Project Name: Wolverine Community Schools Middle-High School Boiler Replacement Project

JLK Project Number: WCS 1701

Addendum Number: #2 – Clarifications & Changes

DATE	ISSUED FOR	DATE	ISSUED FOR	JOB NO.	SHEET
6/9/2017	BIDDING & PLAN REVIEW	6/19/2017	ADDENDUM #2	WCS 1701-01	M3

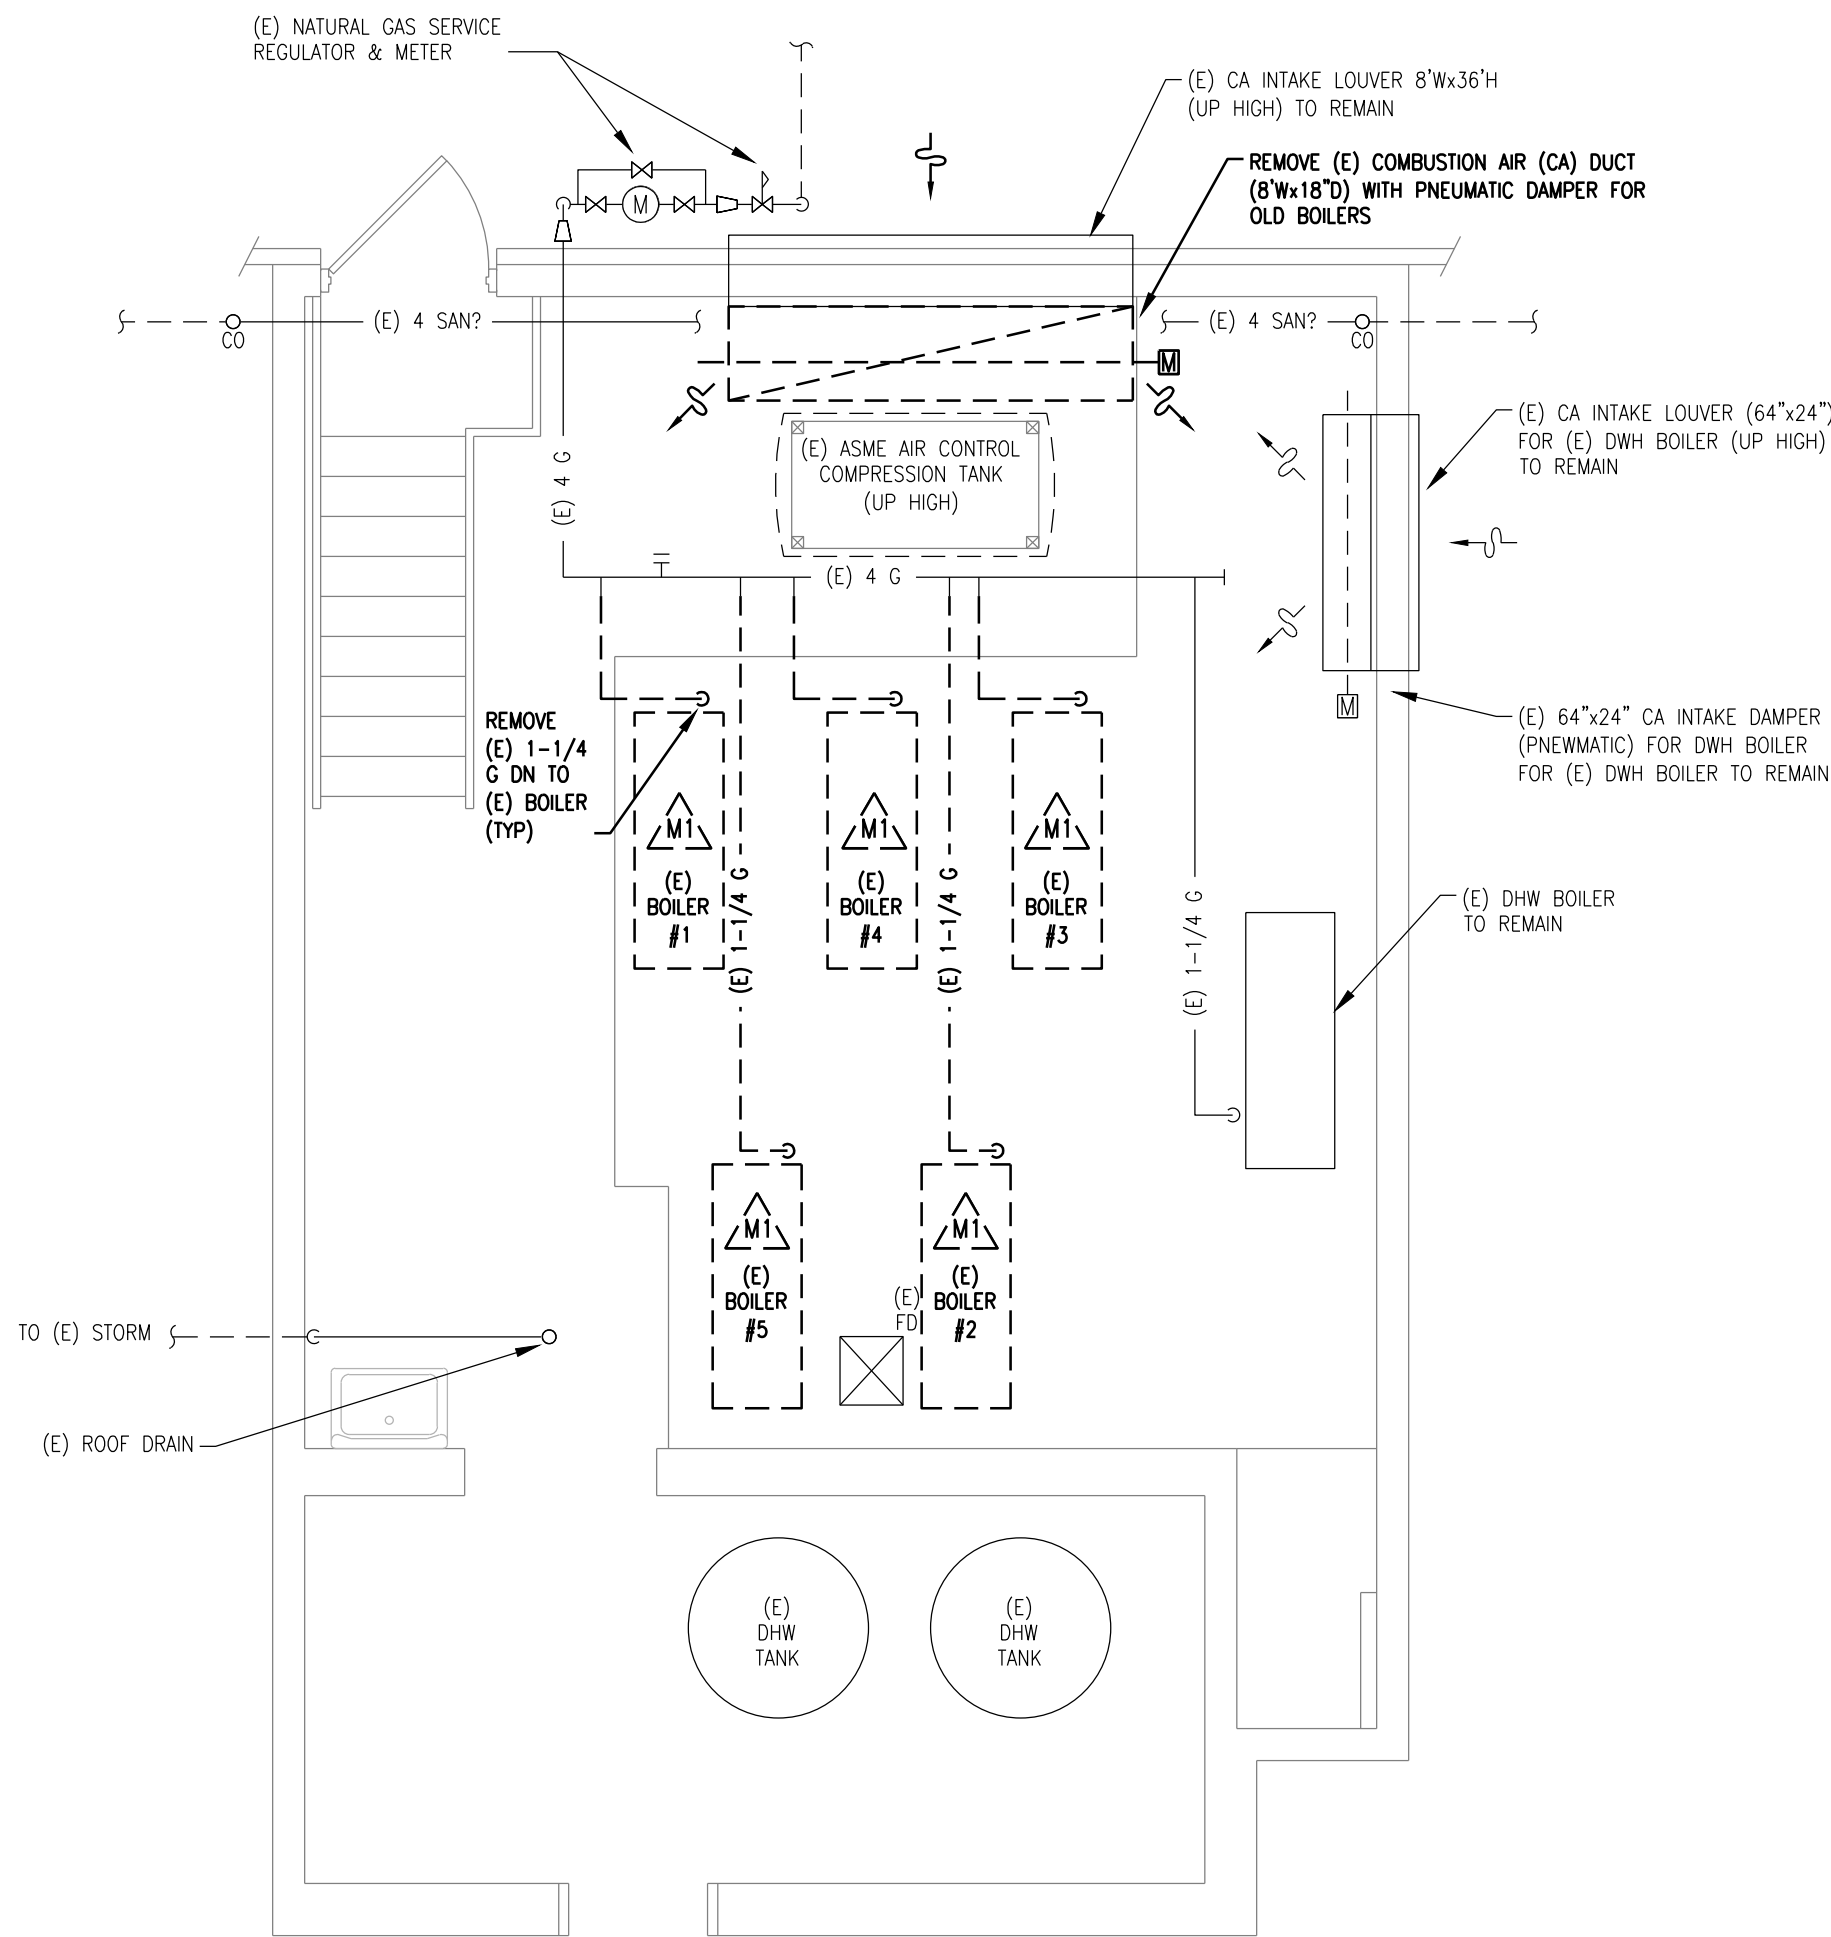
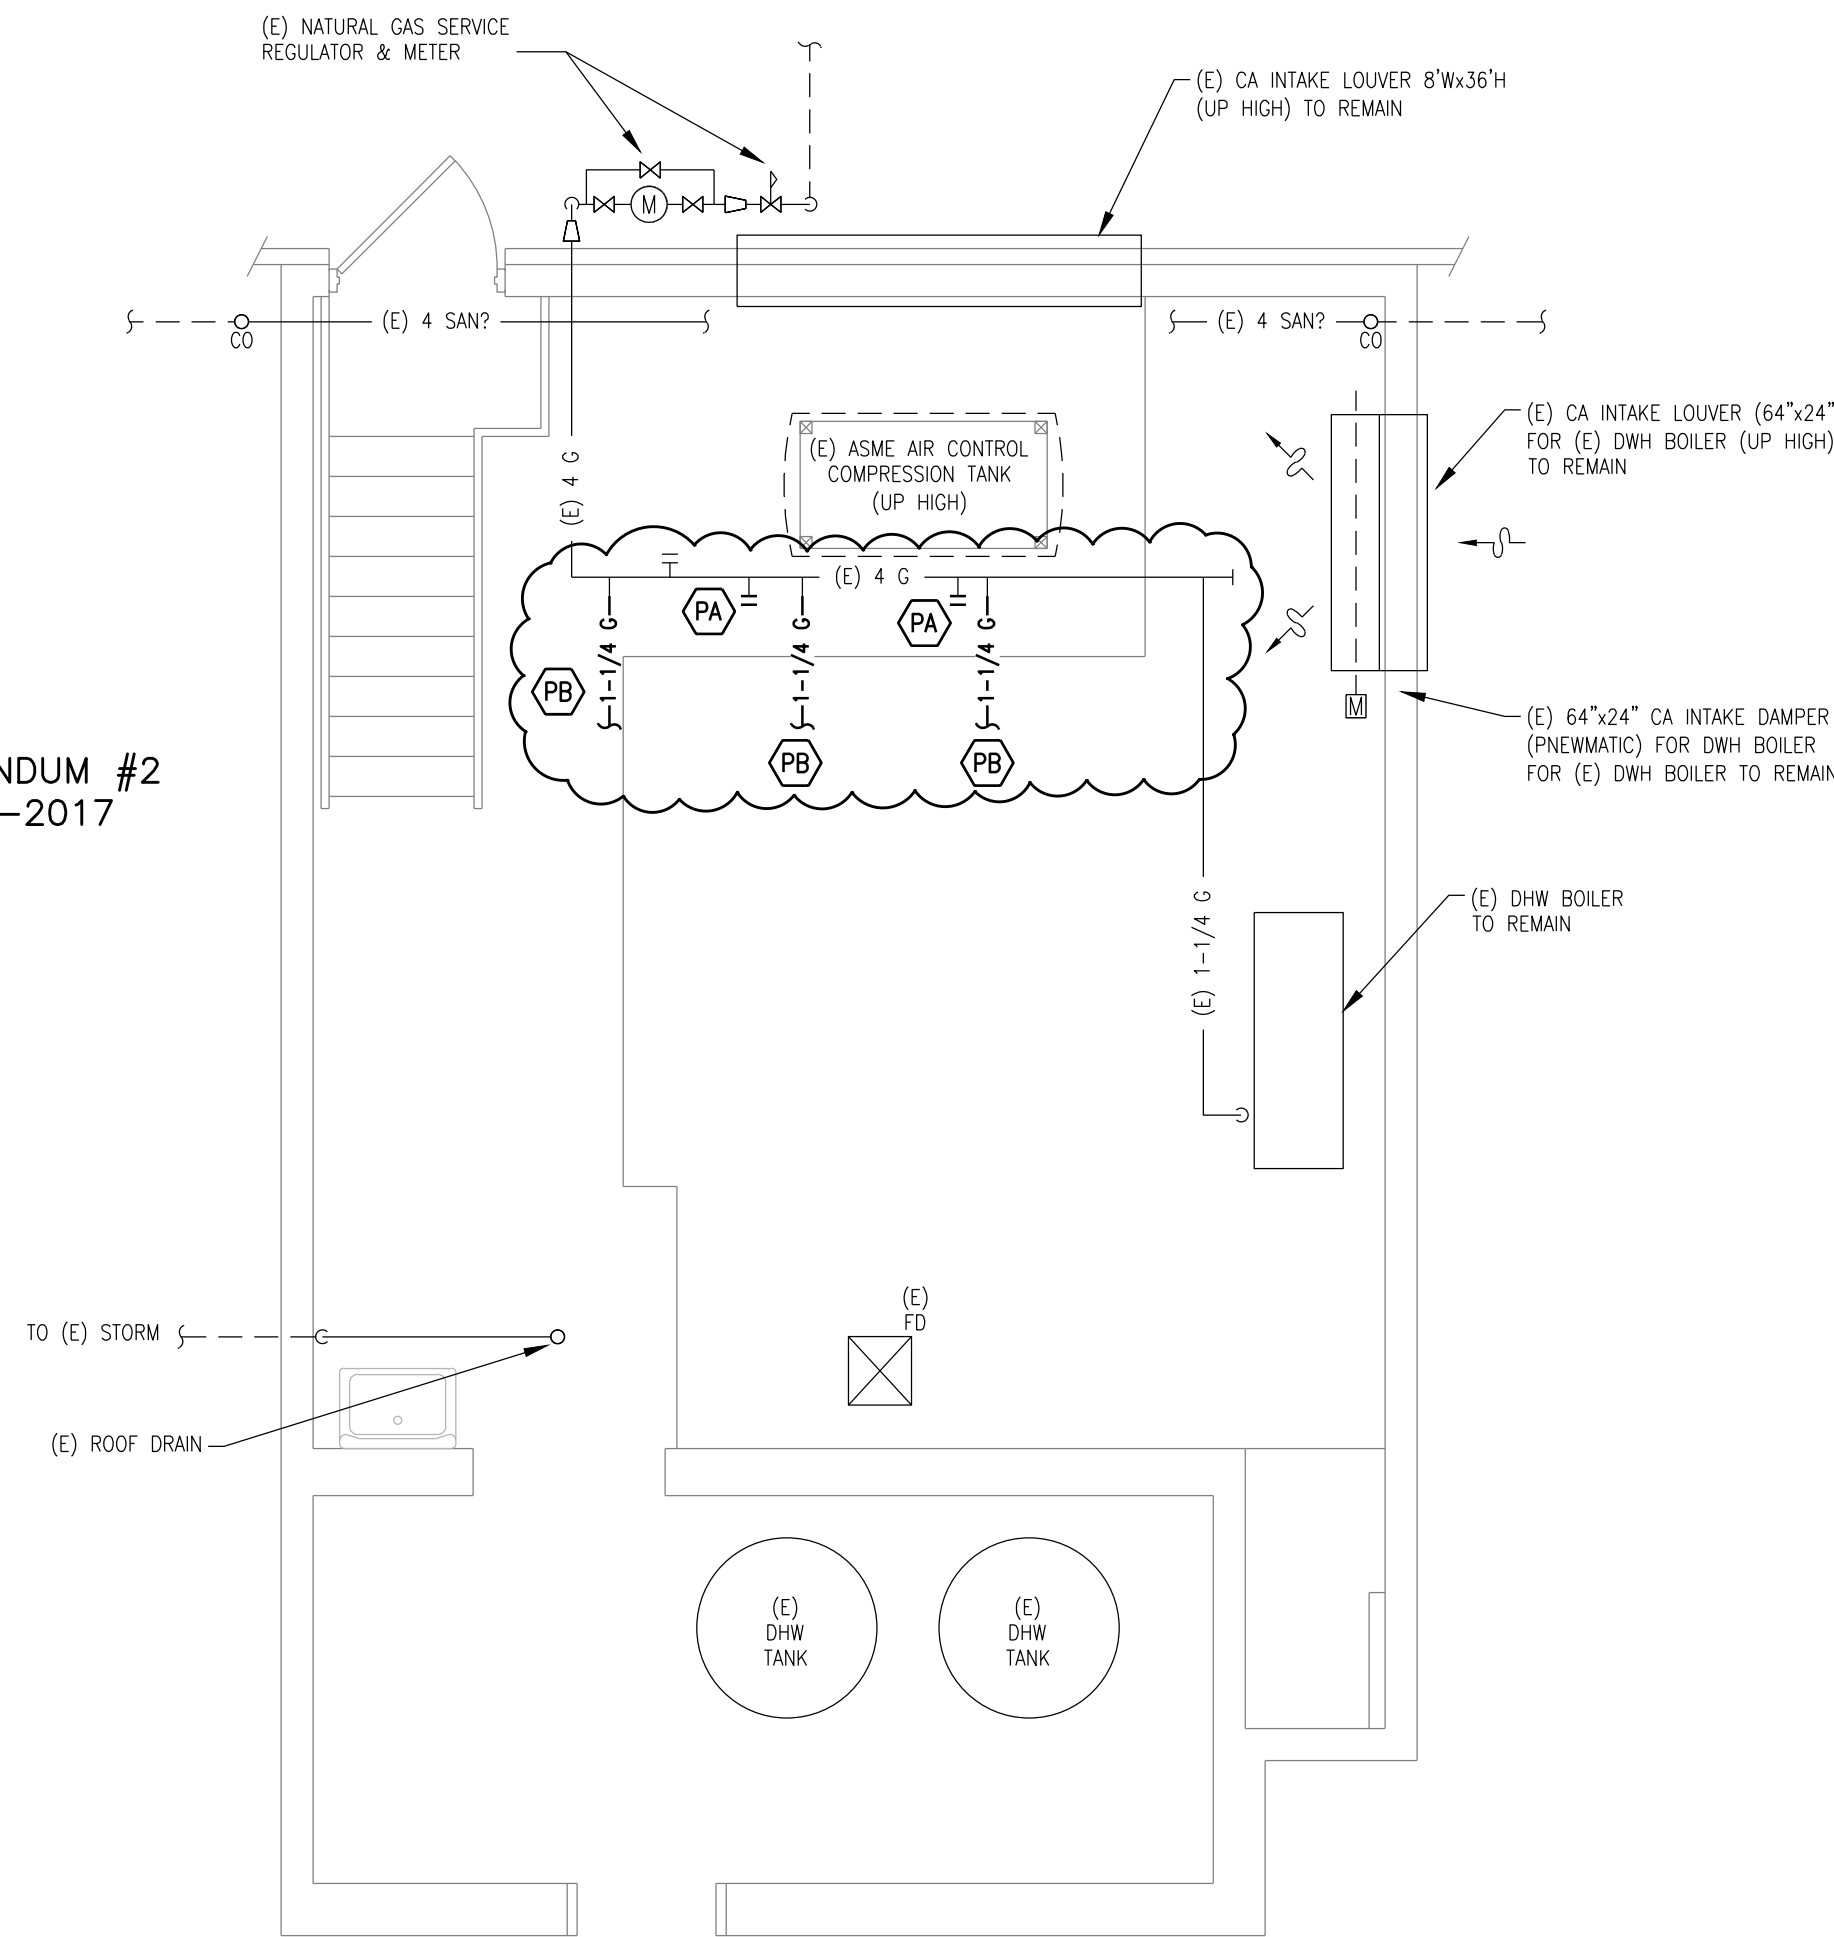
P1. Refer to drawings M3 and M5, both of which are revised and reissued with this addendum. Note the changes to the gas piping work for the new boilers, reuse existing 1-1/4" drops to existing boilers.

- (PA) CAP OFF EXISTING/OLD NATURAL GAS DROPS TO OLD/REMOVED BOILERS, TYPICAL 2X.
- (PB) PROVIDE NEW 1-1/4" NATURAL GAS PIPING DROPS TO NEW BOILERS. REDUCE TO 1" NEAR BOILER AND INSTALL DIRT LEG, ISO. VALVE, AND UNION NEAR THE BOILER. REFER TO BOILER PIPING DIAGRAM.
